CALIFORNIA ENERGY COMMISSION
Attention: Docket No. 12-BSTD-1
Dockets Office
1516 Ninth Street, MS-4
Sacramento, CA

Carrier Corporation, a division of United Technologies has review the proposed 45 day language posted on the CEC web page as of Feb 24, 2012 and would like to file the following comments and proposed changes. We realize that the comments are late, but most of the comments are to correct minor wording errors and references. Any substantive comments have already been filed thru the combined industry comments from AHRI. I have included some of the comments submitted to AHRI for completeness.

**TITLE 24-2013 ECONOMIZER
REQUIREMENTS**

Drybulb Changeover Results

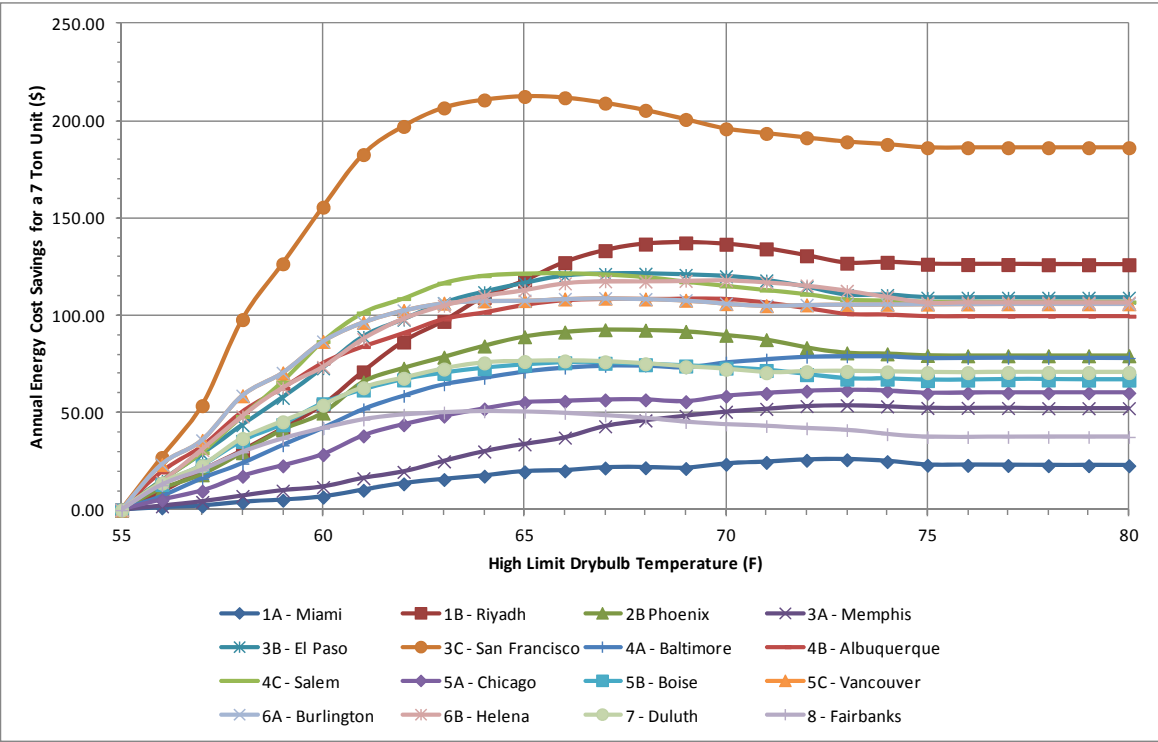
- This is the same data but plotted to show where the peak energy savings occurs and that the curve in the range of the setpoints is very flat.
- From this you can see that many of the Title 24 changes are higher than the peak energy savings changeover setpoint and could be lowered.
- This has an advantage of protecting the space from humidity problems on days with high relative humidity
- Also it shows that you can change the setpoints with very little impact on operating cost which indicates the tolerance is not as critical as assumed when a +/- 1 F tolerance was specified.

- Consider some decrease in the fixed drybulb setpoints as most appear to be higher than the peak value.
- Consider some increase to the offset for the differential drybulb
- Remove the requirement for wetbulb and humidity sensors accuracy as they are not used in the requirements
- Increase the drybulb tolerance to +/- 2 F for fixed drybulb and add a range requirement of 60 to 80 F
- Add a requirement for differential drybulb tolerance of +/- 3 F tolerance with a range of 0 to 15 F
- Increase the enthalpy tolerance to +/- 3 Btu/lbm with a range of 25 to 35 Btu/lbm

Drybulb Tolerances

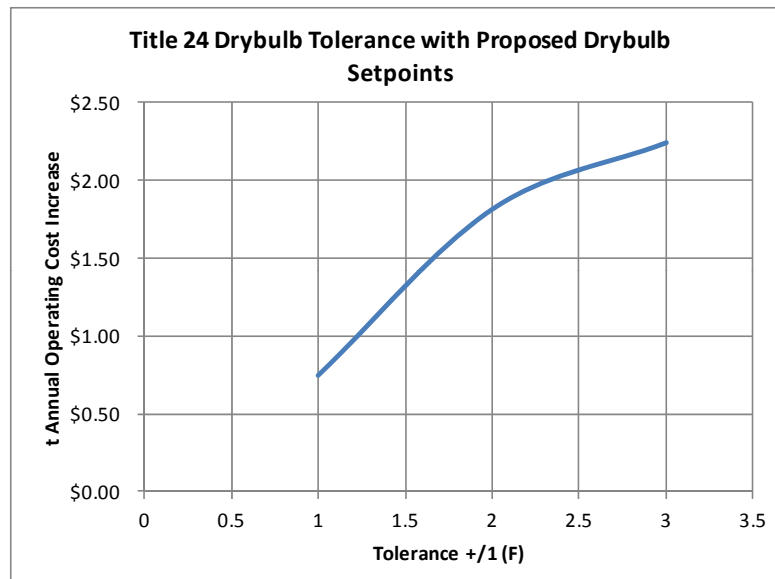
- Taking the prior chart you can then plot the operating cost increase as a function of the 1, 2, and 3 F tolerance

- As you can see if we doubled the tolerance to +/- 2 F the operating cost on average only increased \$1.75 per year for the 7 ton system
- Assuming a base cost for the sensor of \$20 and that the +/-1 F tolerance would double the cost it would have a payback of 11.4 years using the ASHRAE 90.1 power cost. This is well beyond a reasonable payback.
- **We recommend to tolerance be increased to +/-2 F for a temperature range of 60 to 80 F ambient temperatures**

Peak Enthalpy Changeover Setpoint

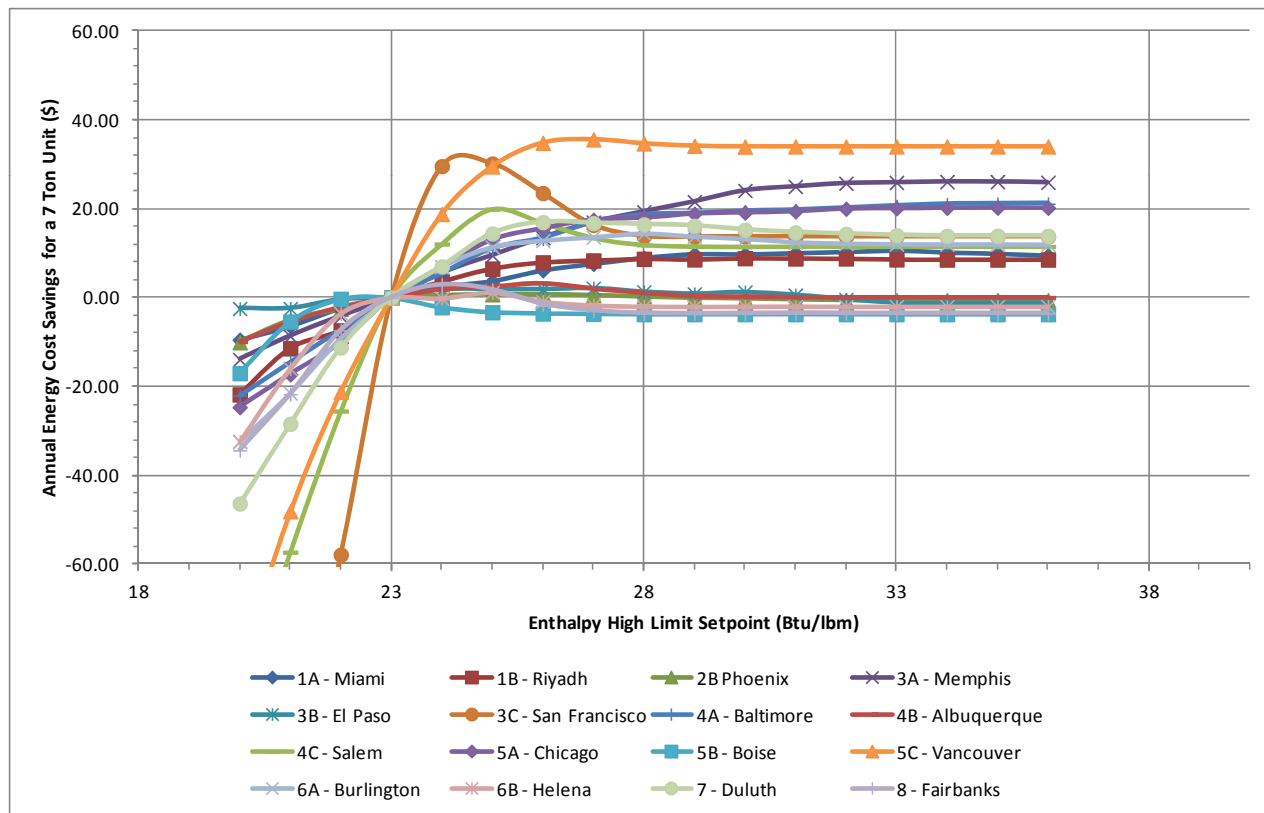
- The following is a plot of the energy savings
- Again it shows that in the range of a 28 Btu/lbm setpoint that the curves are flat and changes or tolerances will not have a big impact.

Enthalpy Tolerances

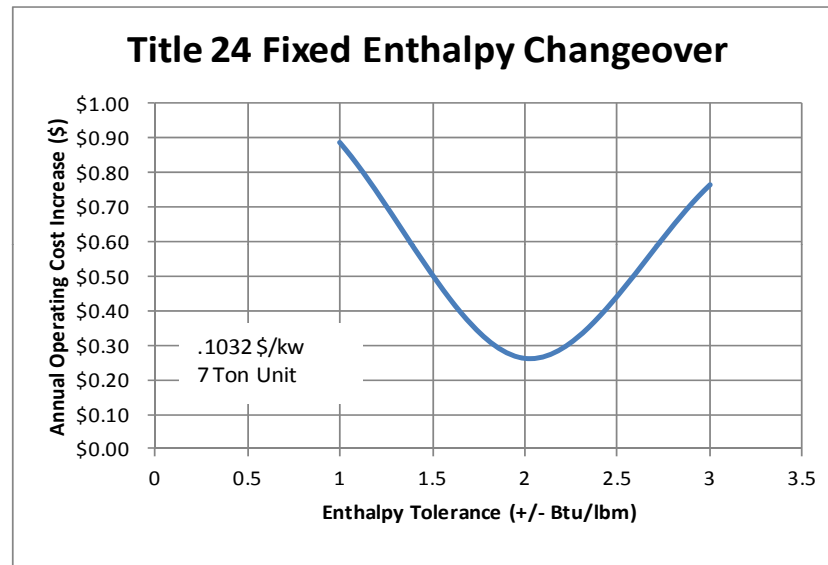
- Taking the prior chart you can then plot the operating cost increase as a function of the 1, 2, and 3 Btu/lbm tolerance

- As you can see if we triple the tolerance to +/- 3 Btu/lbm that the operating cost increase vs. zero tolerance is only \$.76 per year.
- Vs the 1 Btu/lbm tolerance the 3 Btu/lbm tolerance is actual lower in energy cost impact as the 28 Btu/lbm is not the optimum
- **We recommend to tolerance be increased to +/-3 Btu/lbm for a range of enthalpy of temperature range of 25 to 35 Btu/lbm enthalpies**

Peak Differential Drybulb Offset Setpoint

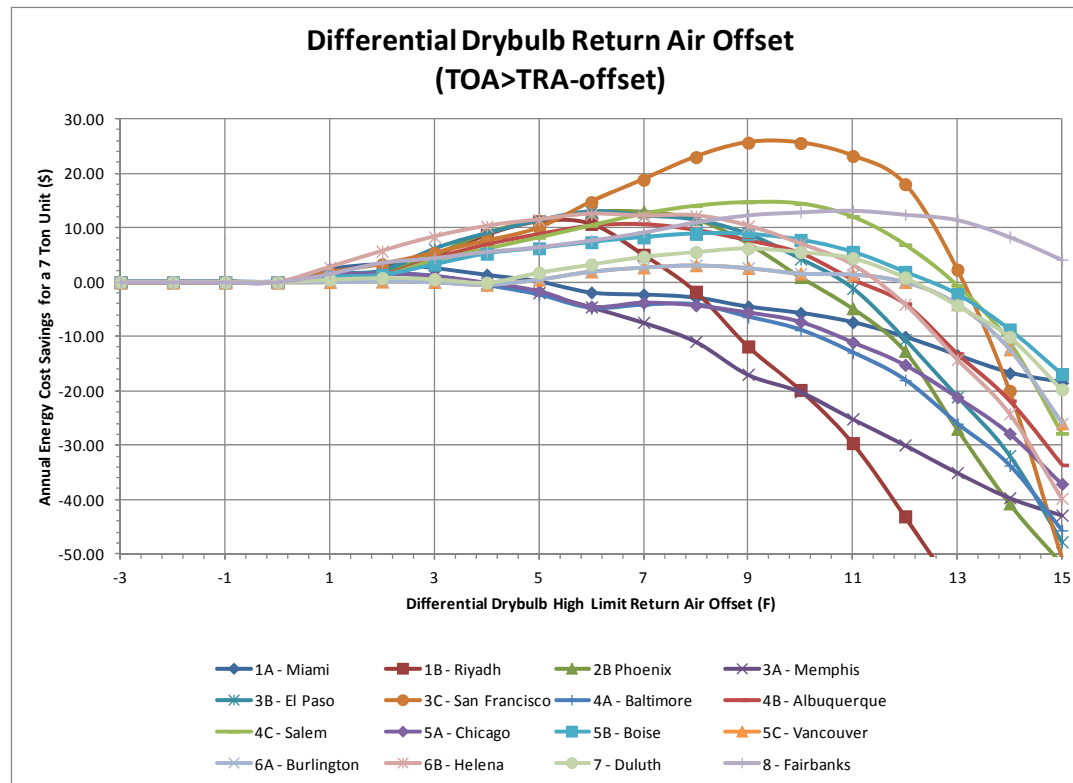
- The following is a plot of the energy savings for the differential drybulb changeover relative to the return air offset of 0 F.

- This has more of a peak than pure drybulb, but there is a flat spot for each climate zone of 4 to 5 F.

Differential Drybulb Tolerance Study

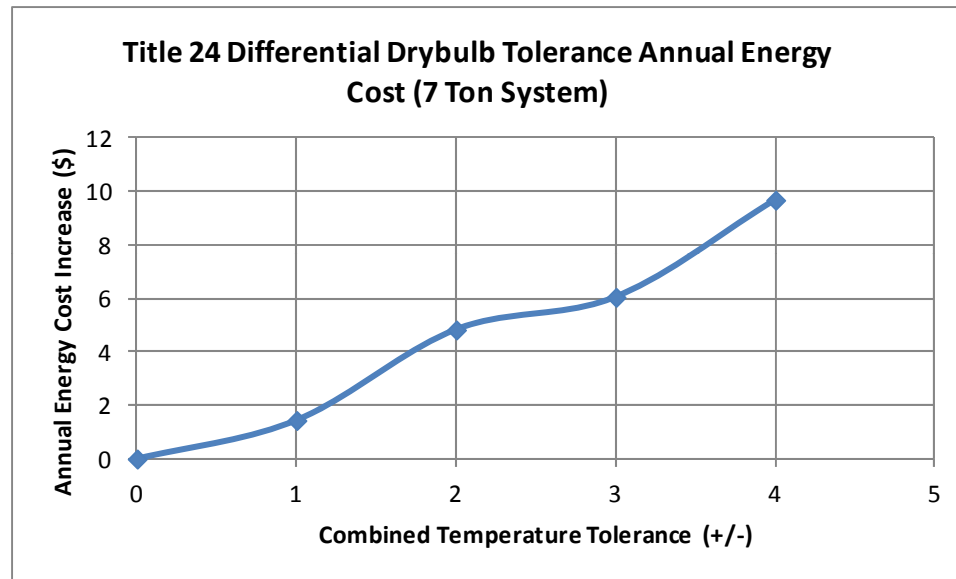
- The following is a plot of the prior chart on differential tolerances

- We feel that a combined tolerance for the differential of +/- 3F would be appropriate. This is slightly tighter than combined error of two sensors with a +/- 2 F but it would encourage the development of differential sensors.
- We are checking with suppliers of sensors to get their feedback, but even a +/-4 F would not be much of a cost penalty.
